MOODNA CREEK WATERSHED INTERMUNICIPAL COUNCIL
COMMENTS ON THE CLOVEWOOD DRAFT ENVIRONMENTAL IMPACT STATEMENT
DECEMBER 3, 2020

TESTIMONY BEFORE THE VILLAGE OF SOUTH BLOOMING GROVE
PLANNING
REGARDING THE CLOVEWOOD DEVELOPMENT
BY JAMES BEAUMONT
CHAIRMAN OF THE MOODNA CREEK WATERSHED INTERMUNICIPAL
COUNCIL
DECEMBER 3, 2020

4" Faircloth Skimmer® Surface Drain Cut Sheet

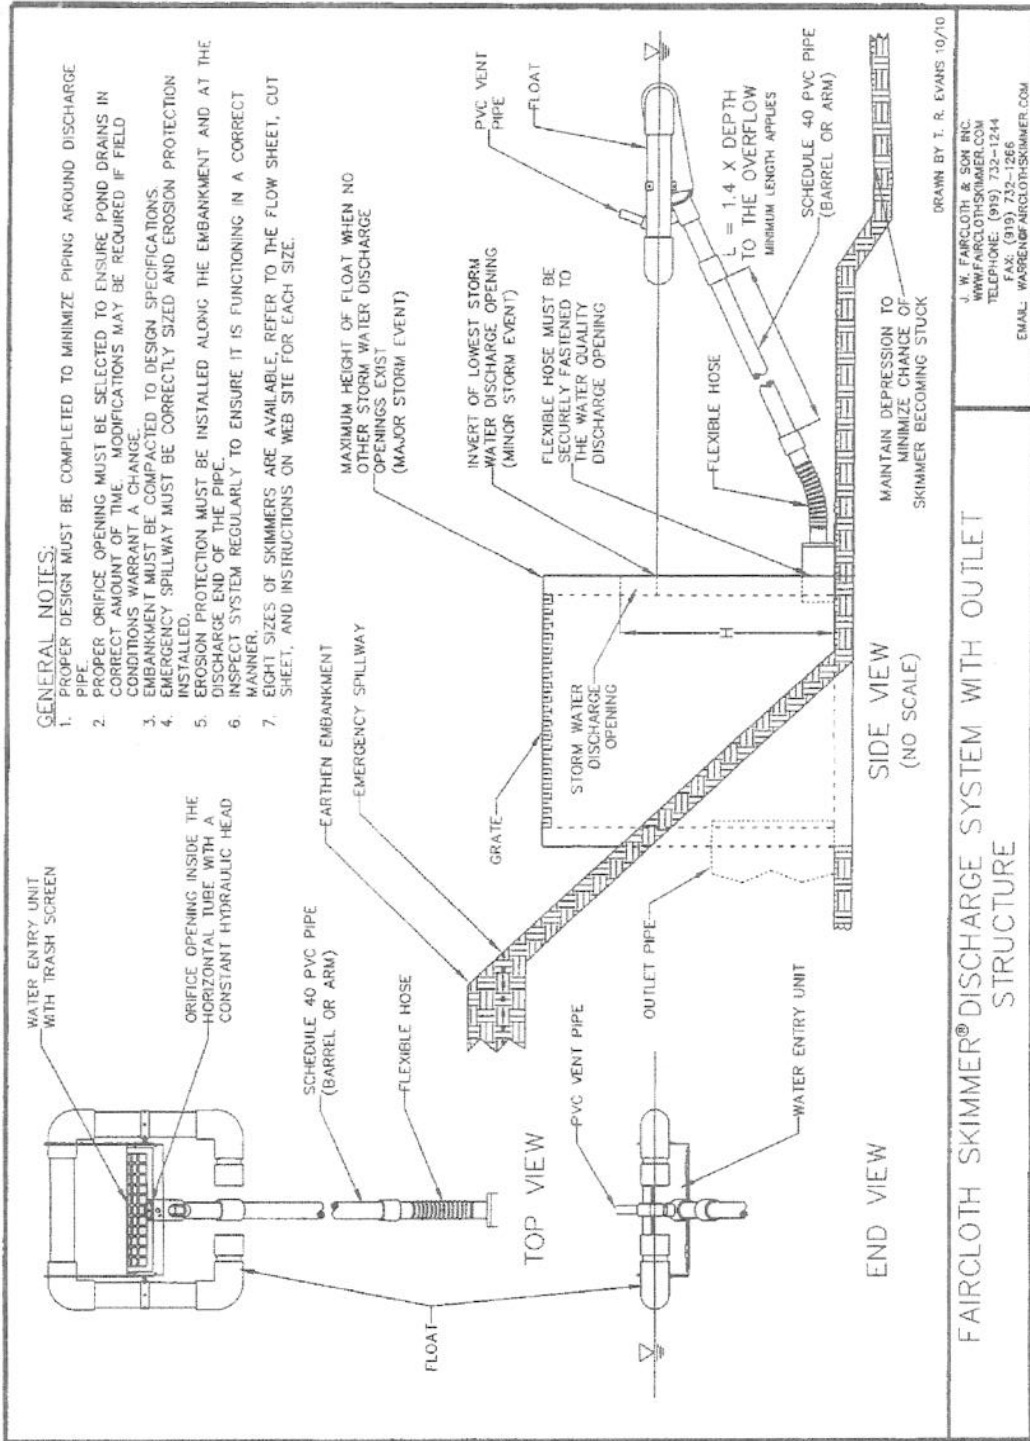
Floating skimmers are very expensive to buy, much cheaper and very easy to make themselves with PVC. See attached sketches.

- Install water skimmers connected to the outlet riser pipe in sedimentation ponds (See Appendix B of the Bluebook and attached diagrams)
- Install sediment filter bags on the downstream end of the outlet pipe. (See page 5.16 of the Bluebook)
